PRODUCT SERVICE ADVISORY & TECH NOTE

PowerFlex 4/40 Reflash Issue

Ref: CPAG 2004-07-002

Date: July 2004

Examples of carton labels prior and after re-flash:

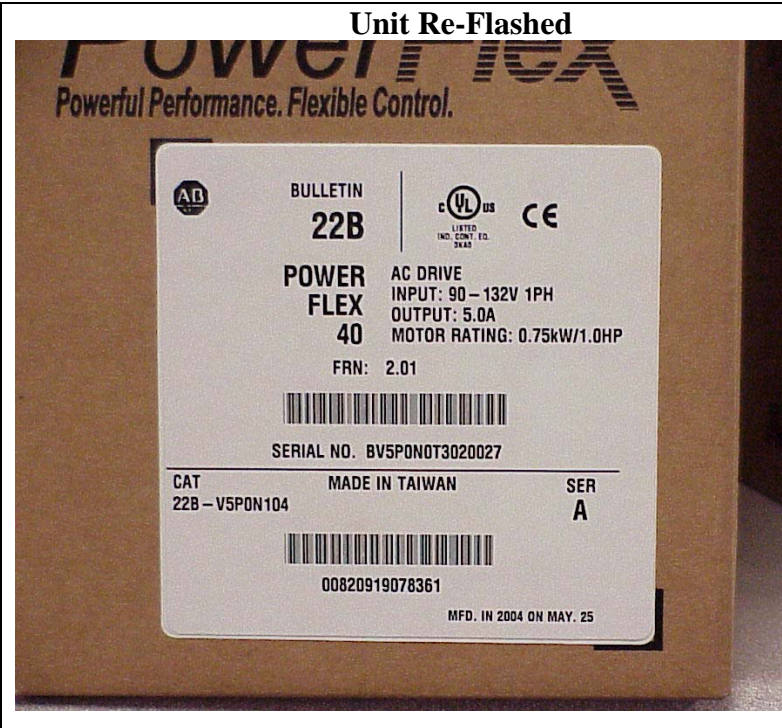
Affected units may be identified by the carton labels displaying Firmware Revision Number 2.01 (for PowerFlex 40) and 3.05 (for PowerFlex 4) it also reflects the small

“A-B Logo” in the upper left hand corner. The attached pictures reflect a factory shipped unit versus a re-flashed unit.

Examples of Product Name Plate prior and after re-flash:

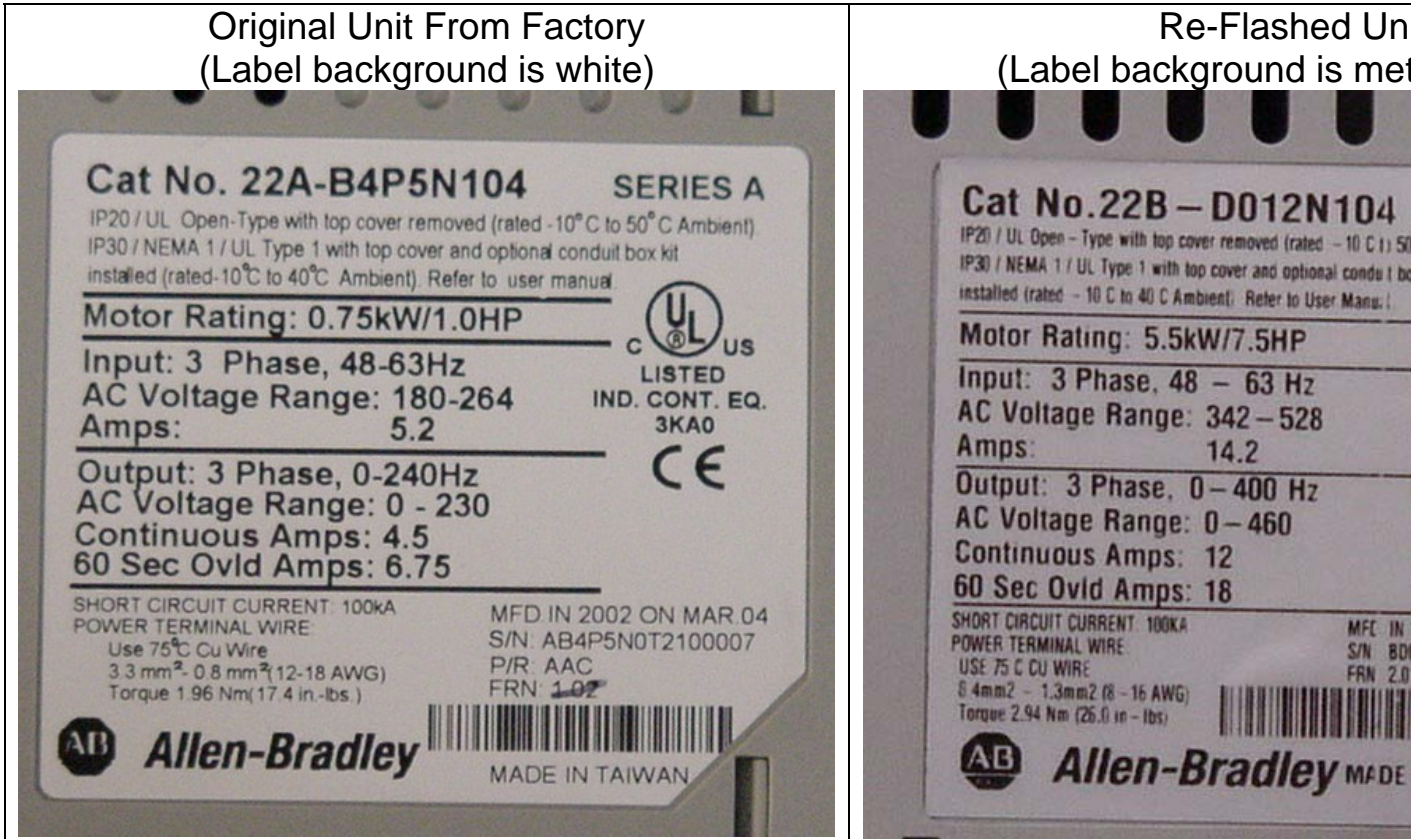
If affected drives were shipped to customers, the drive nameplate label will be metallic silver instead of the standard white label.
